Docket Item # 9
BAR CASE # 2009-0053

BAR Meeting
April 15, 2009

ISSUE: Addition/Alterations
APPLICANT: Beverly Fetty
LOCATION: 420 North Columbus Street
ZONE: CL/Commercial

Figure 8 Proposed rear (west) elevation.

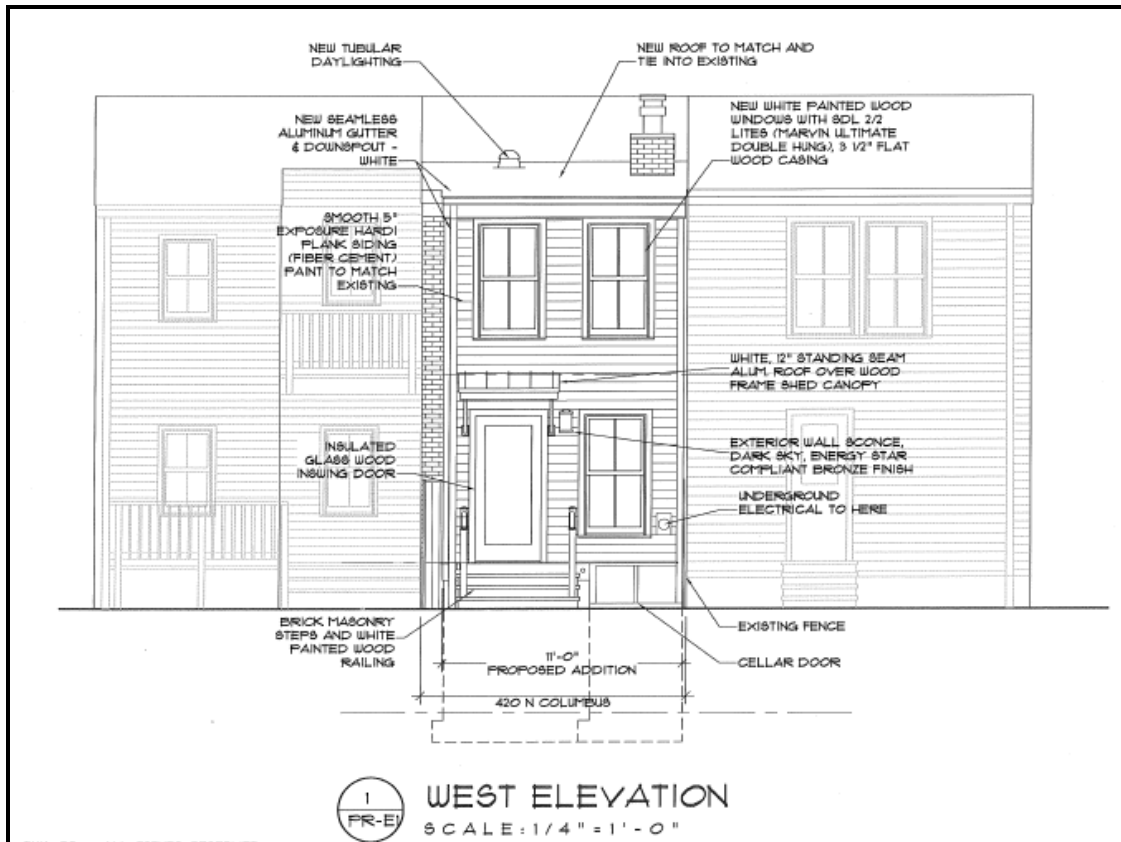
1. That the applicant uses a metallic color standing seam metal roof that may either be allowed to weather naturally or painted to match the trim of the addition rather than the white color proposed in the application.
